Catherine Field Primary School Mod 2 Additional Information – 19th November 2020

SECTION 4.55(1A) MODIFICATION APPLICATION, NEW CATHERINE FIELD PUBLIC PRIMARY SCHOOL (SSD 9477 – Mod 2) – ADDITIONAL INFORMATION

We refer to the Department of Planning, Infrastructure and Environment (DPIE) request for additional information dated 10th November 2020 relating to matters raised by Camden Council. The following information re-states the matters (in *italics*) and provides a response to each.

Swept path drawing for temporary access to car park

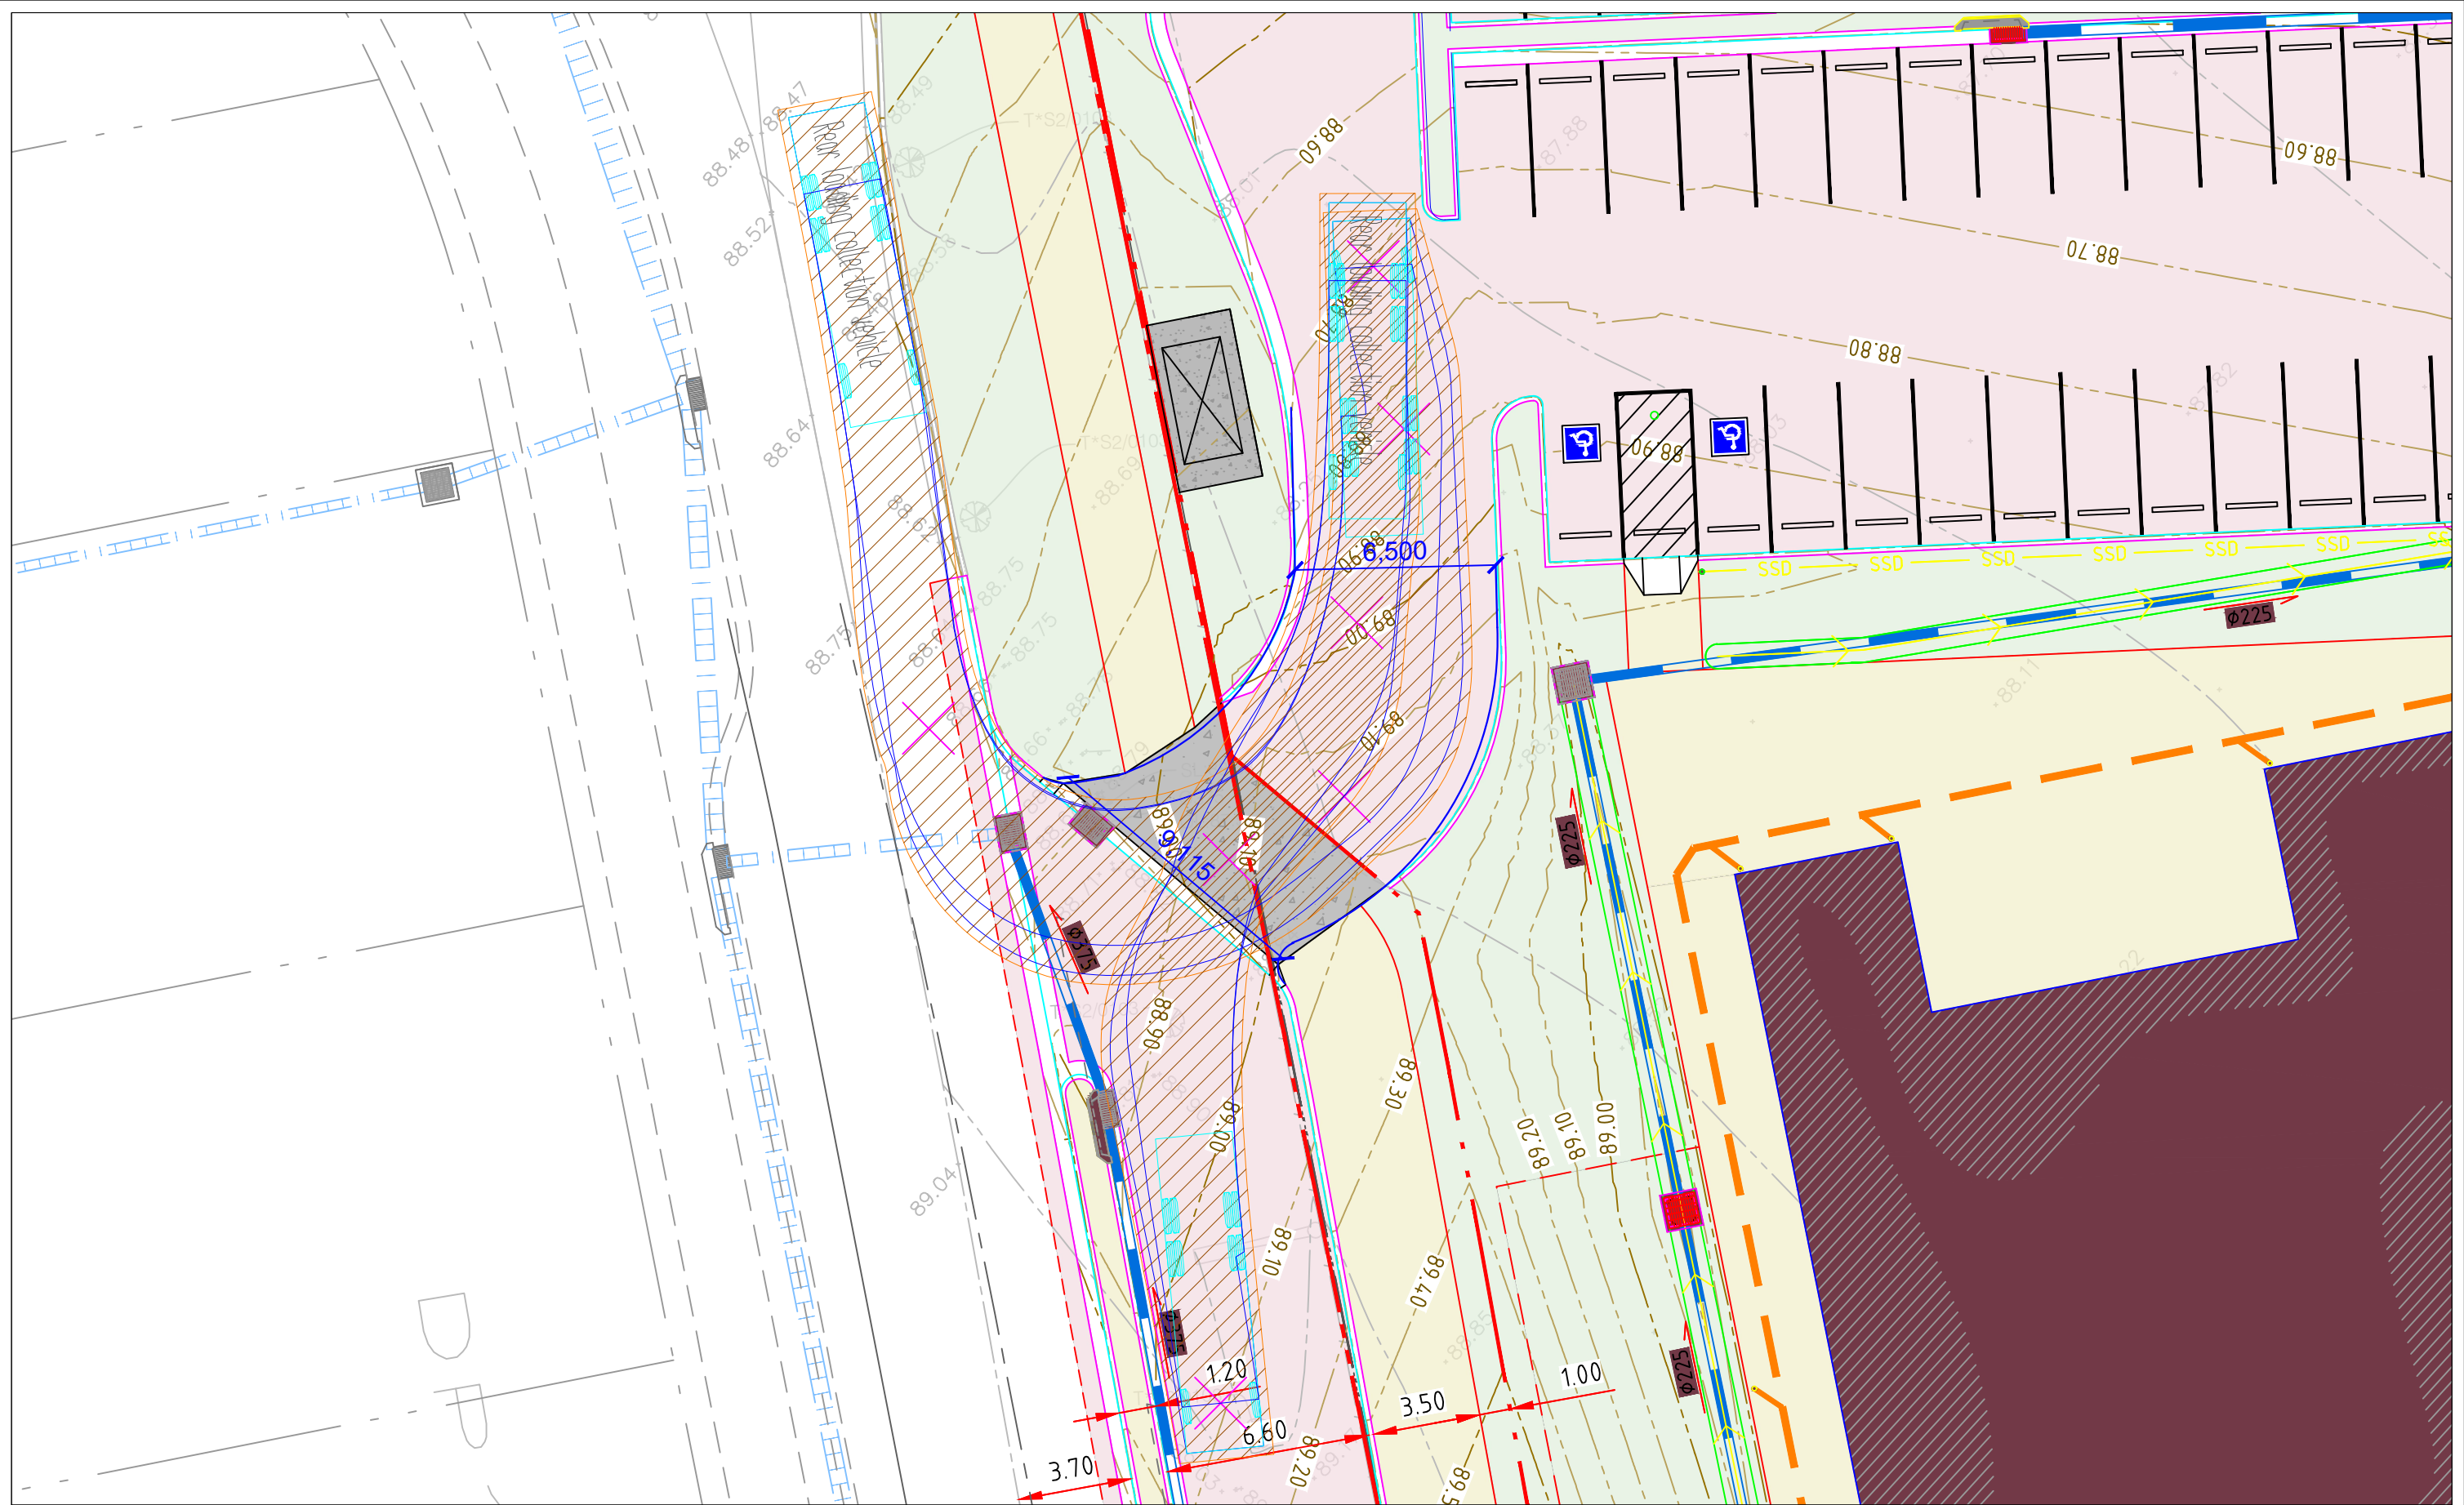
1. *Swept paths shall be submitted showing vehicles entering and exiting the interim car park access*

A swept path plan for a 10.24m waste truck and a swept path plan for B85 and B99 design vehicles are contained in **Appendix A**. The plans have been prepared by Anson Group and indicate that these vehicles will be able to enter and exit the interim car park access in accordance with the requirements of the relevant Australian Standards.

Landscape plans for southern perimeter road

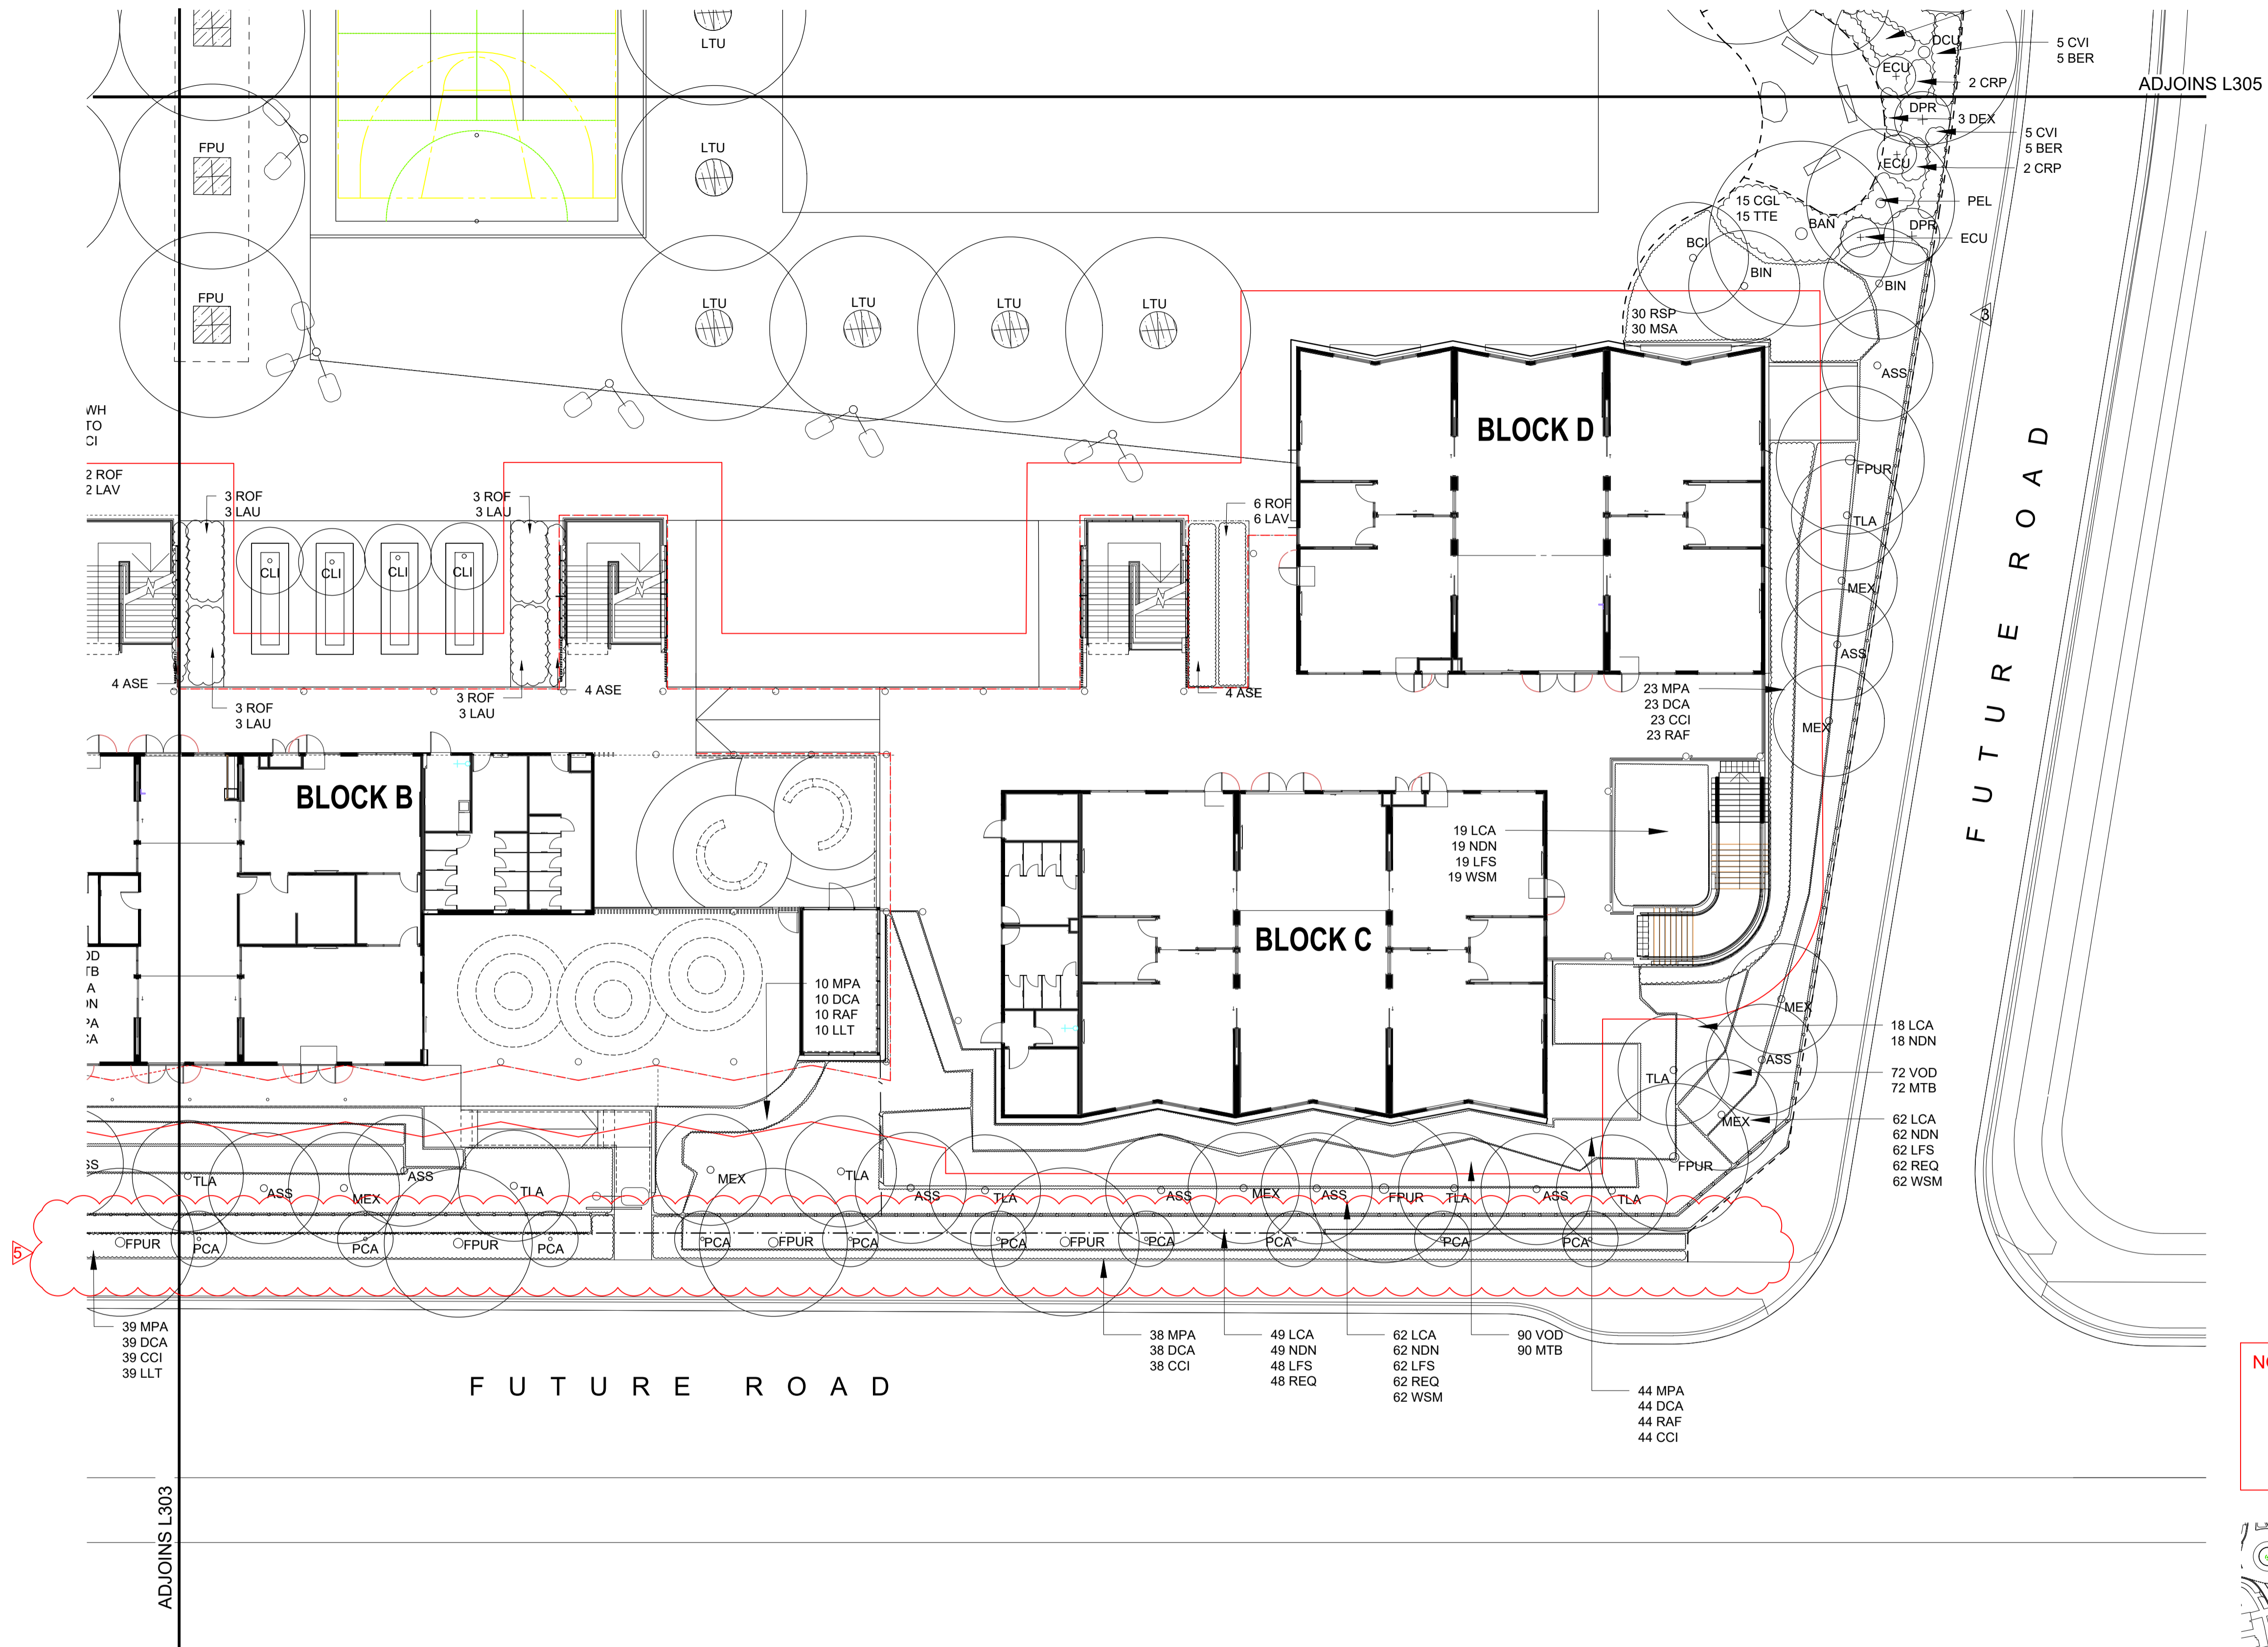
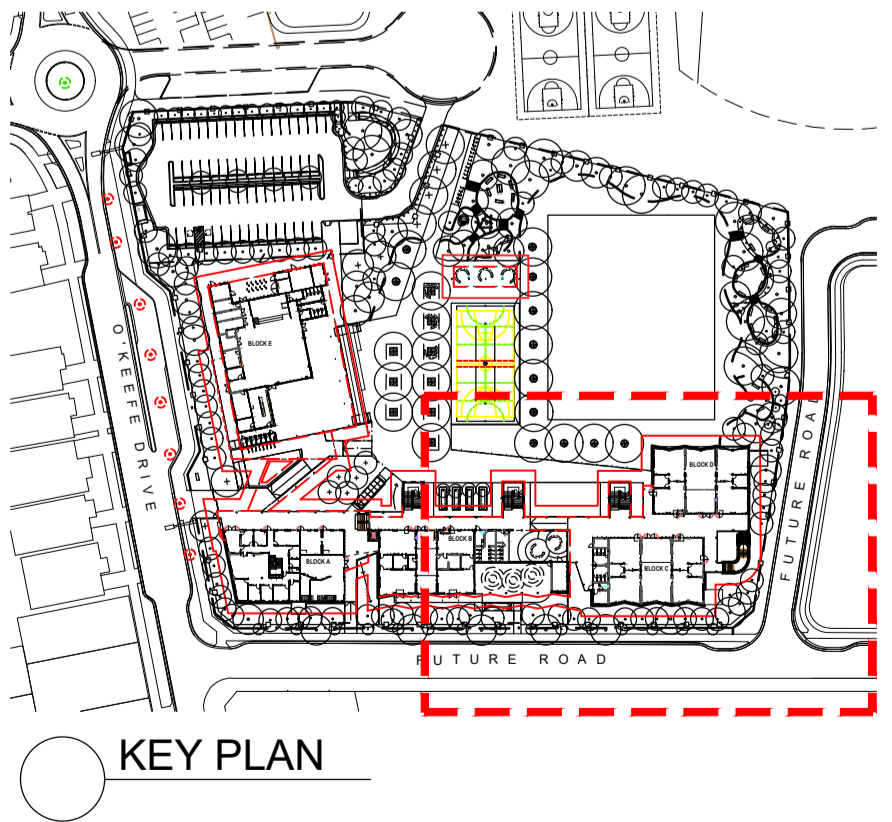
7. *The landscape plans submitted with the application show the removal of all street trees along O'Keefe Drive and no street trees along the southern perimeter road. There appears to be ample opportunity to plant street trees in the unencumbered areas of these road verges. Street trees should be avoided near the entrance and exit of the kiss and drop / interim car park to avoid blocking sight lines.*

Street trees are nominated within the southern perimeter road. Consultation with neighbouring developers and Council representatives has occurred and included consideration of required footpath widths. Updated landscape drawings are provided in **Appendix B**.
